RE: Main Street pedestrian footpaths to the town centre for the proposed mixed-use development.

This statement is provided by Morris Goding Access Consulting (MGAC) in support for the proposed mixed-use development located at 43-53 Cudgegong Road, Rouse Hill NSW 2155.

Attached Documentation

ROAD No.3 (MAIN STREET) - PLAN

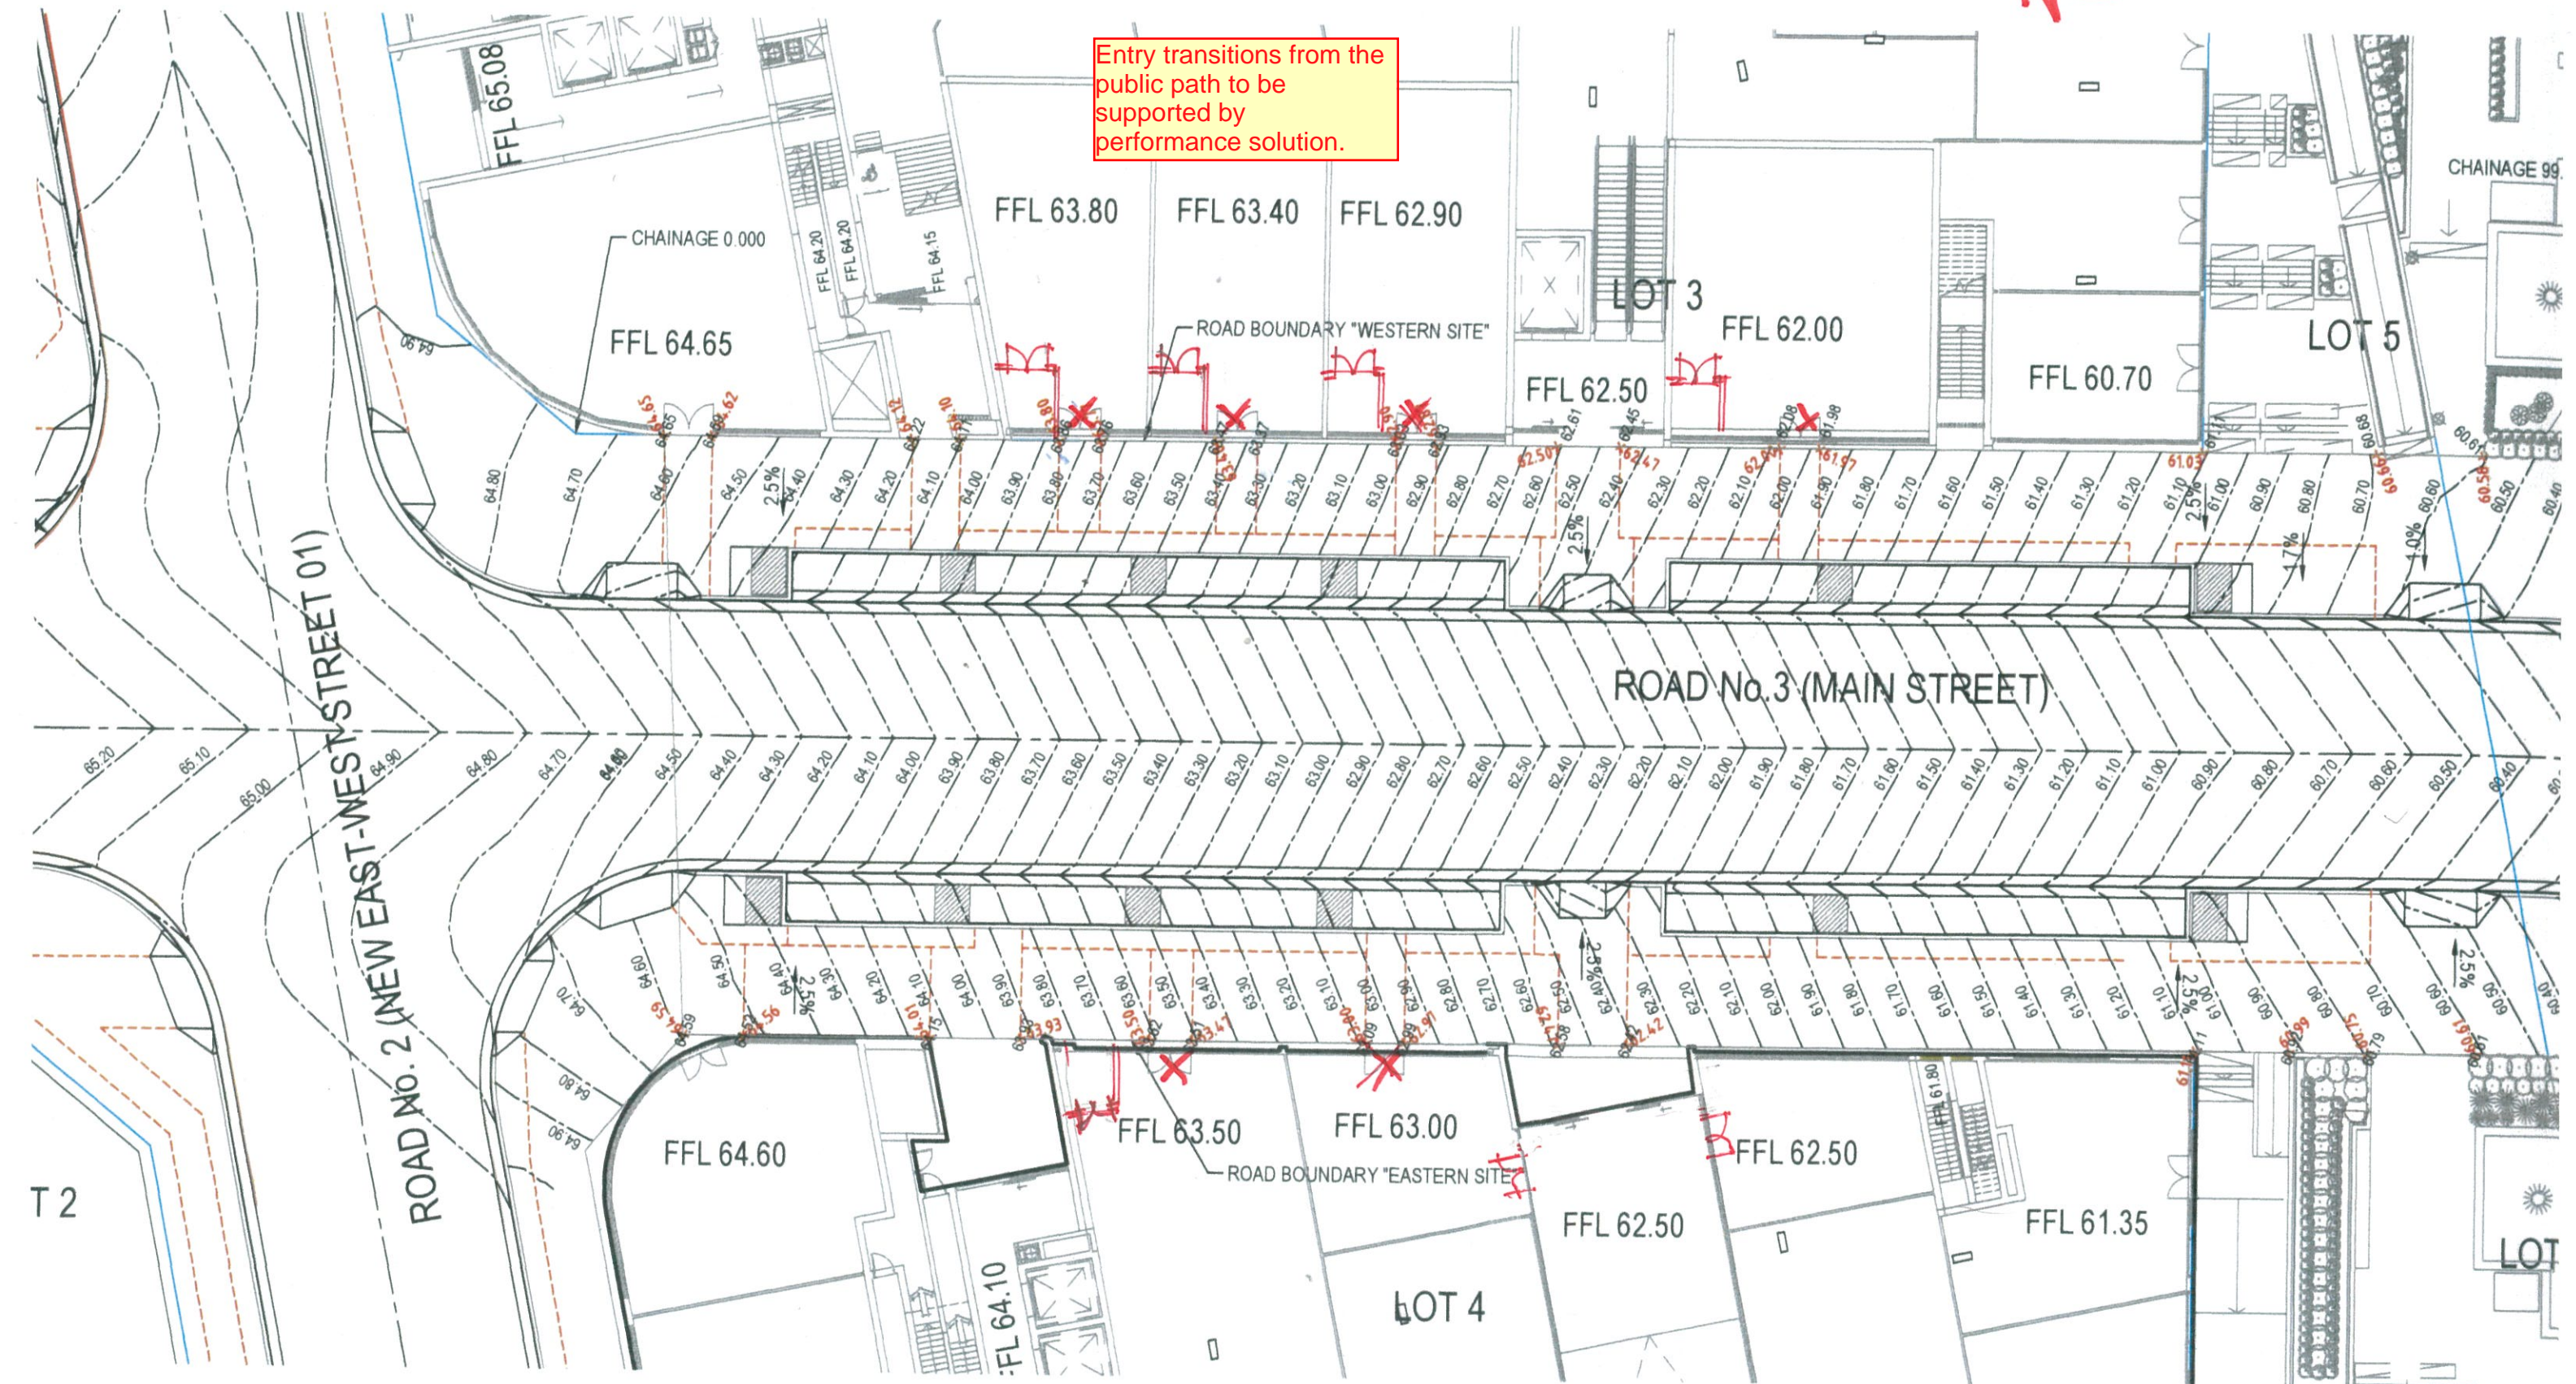
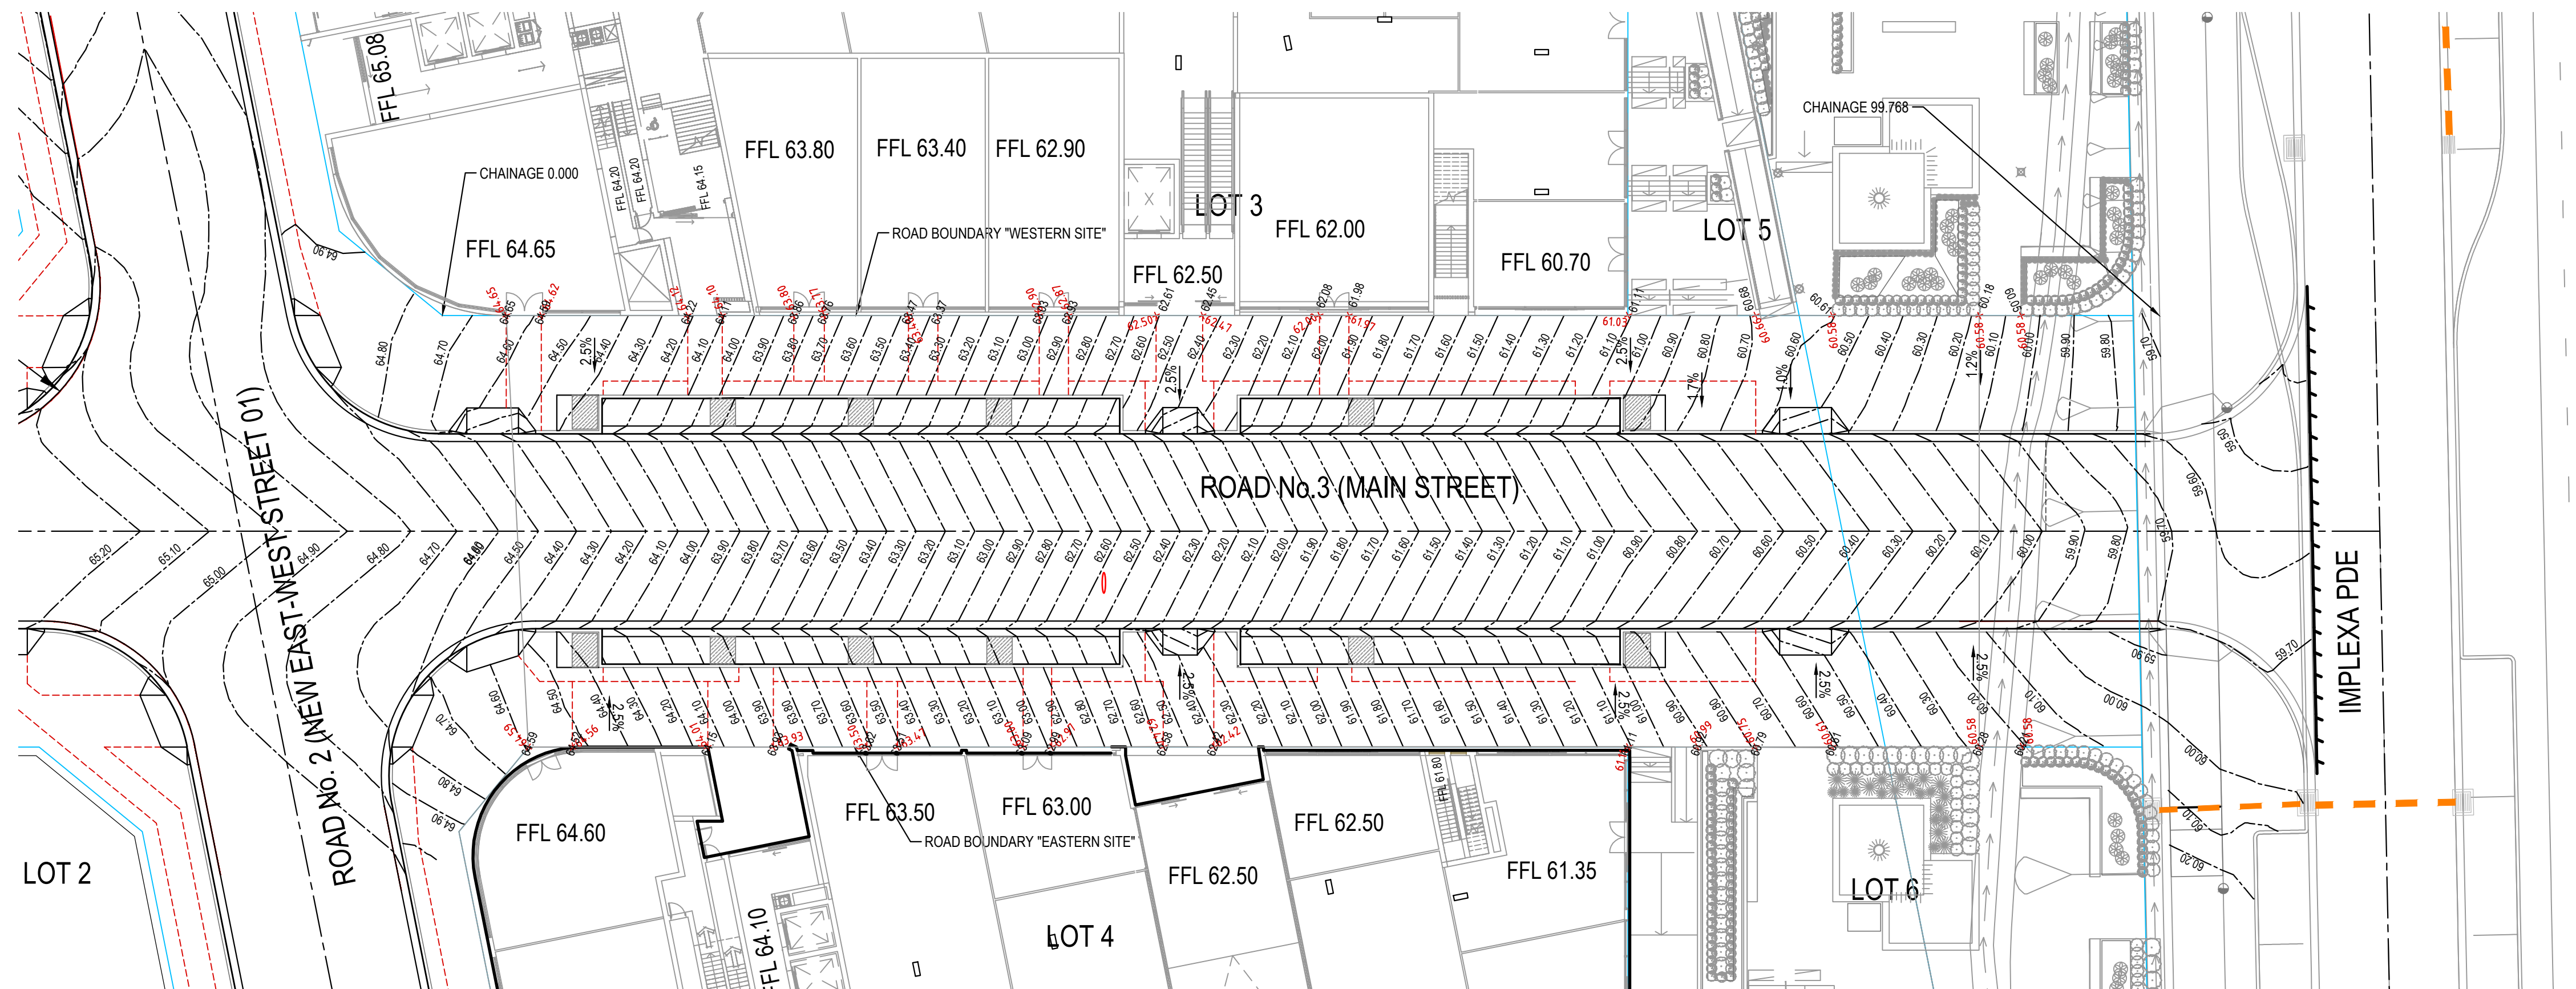
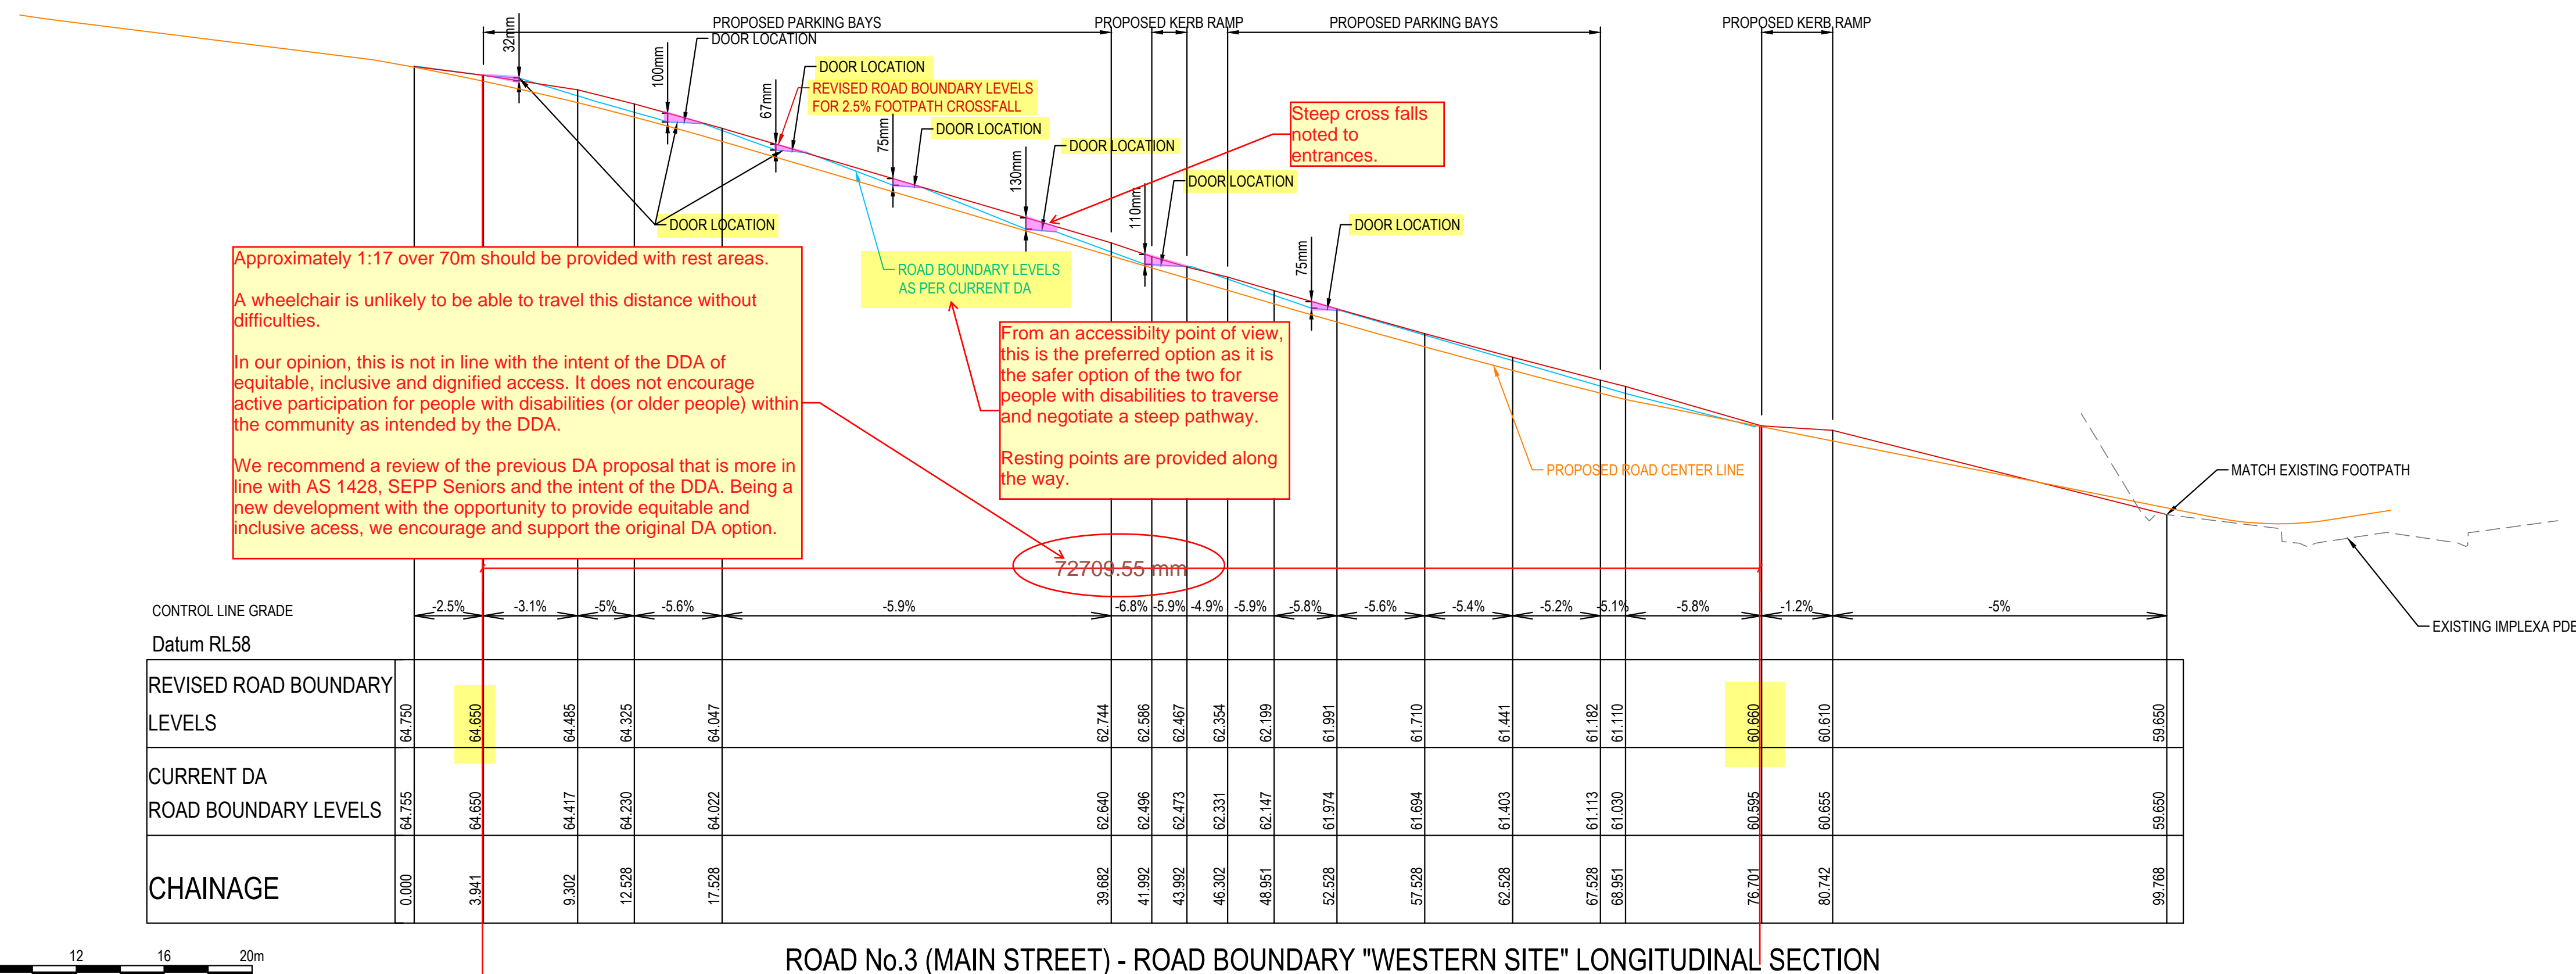
For 1:17, landing intervals (resting points) should be provided at every 12m, at a landing length of at least 1200mm and 1500mm at 90-degree turns such as at pedestrian cross over (2000mm preferred in public domain areas as passing spaces).

Entry transitions from the public path to be supported by performance solution.

ROAD No.3 (MAIN STREET) - ROAD BOUNDARY "WESTERN SITE" LONGITUDINAL SECTION

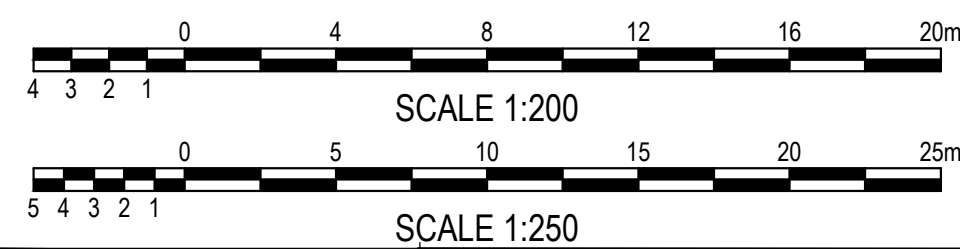
Contention 1(f) – Pressed. Council's position remains that the public realm (footpath within the verge) is to be designed as a consistent gradient for the full length of the development. The design on Drawing DA-3-105 Revision C results in an undulating footpath with gradients as steep as 1:10 (twice as steep as the recommended 1:20).

There are further increased safety risks that arise from the introduction of varying width and length transition zones and ramped areas. All levels changes and transitions to enable access to the retail tenancies is to be accommodated within the subject site and not within the public domain.

As the new Main Street will have a gradient of approximately 1:25 to the centreline, it can be assumed that the footpath within the verge can achieve a consistent gradient of 1:20, if not 1:25. This would require modest modifications to the floor levels within the retail tenancies and adjustments to the doorways to provide accessible gradient transitions within the subject site.

As the AHRC draws on the advice of AS 1428. A 1:20 grade hence should provide landing at every 15m intervals, and a 1:17 grade requires landing at every 12m intervals. A one continuous 1:17 length presents a greater safety risk for people with disabilities and older people than varying lengths with landing zones, which is permitted/required under AS 1428 and SEPP Seniors as stated above.

1:17 crossfall is not ideal for safe transitioning. A level landing will provide accessible and safe transition and we support this .
